UNITED STATES PATENT AND TRADEMARK OFFICE

APPLICATION NO.	FILING DATE	FIRST NAMED INVENTOR	ATTORNEY DOCKET NO.	CONFIRMATION NO.
10/753,426	01/09/2004	Chui-Kai Peng	MR2561-144	6738
4586	7590	09/20/2005	EXAMINER	
ROSENBERG, KLEIN & LEE 3458 ELLICOTT CENTER DRIVE-SUITE 101 ELLICOTT CITY, MD 21043			CHANDRAN, BIJU INDIRA	
			ART UNIT	PAPER NUMBER
			2835

Office Action Summary	Application No. 10/753,426	Applicant(s) PENG, CHUI-KAI	
	Examiner Biju Chandran	Art Unit 2835

DETAILED ACTION

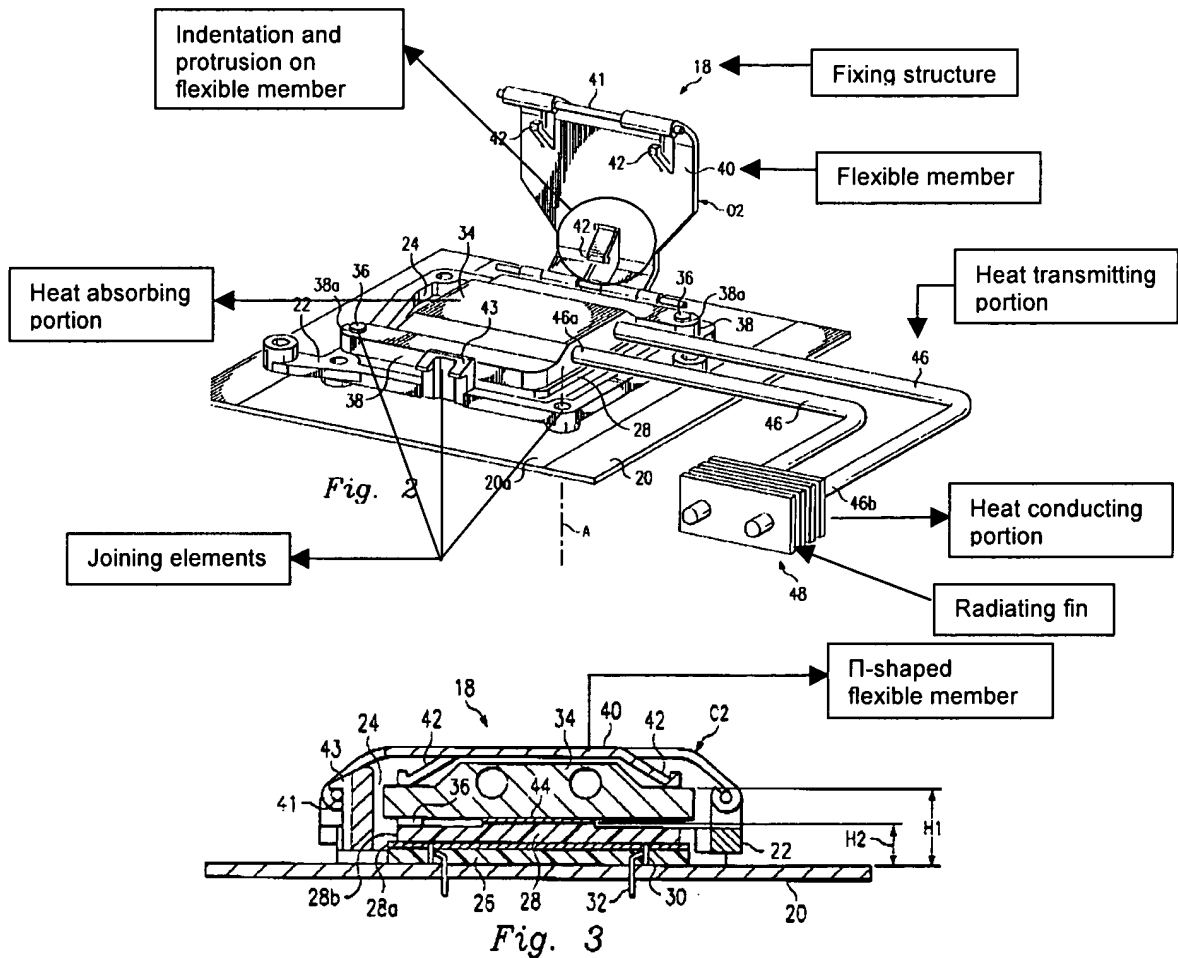
- Regarding claim 1, Shabbir et al. disclose an improved thermal module adopted for use on an electronic device that generates a small amount of heat, comprising: a heat absorbing portion (34) for absorbing the heat generated by the electronic device (28) during operation; a heat-transmitting portion (46) having one end connecting to the heat-absorbing portion to deliver the heat absorbed by the heat-absorbing portion; and a heat-conducting portion (48) connecting to another end of the heat-transmitting portion for dispersing the heat delivered from the heat-transmitting portion to the ambient.

- Regarding claim 2, Shabbir et al. discloses all the limitations in claim 1, they further disclose the improved thermal module having a fixing structure (18) and a plurality of joining elements (marked in figure), the fixing structure including a flexible member (40) which is a thin plate to cover the heat-absorbing portion and has outer rims to form a fastening structure (marked in figure) to couple with the joining elements to fasten the heat-absorbing portion.
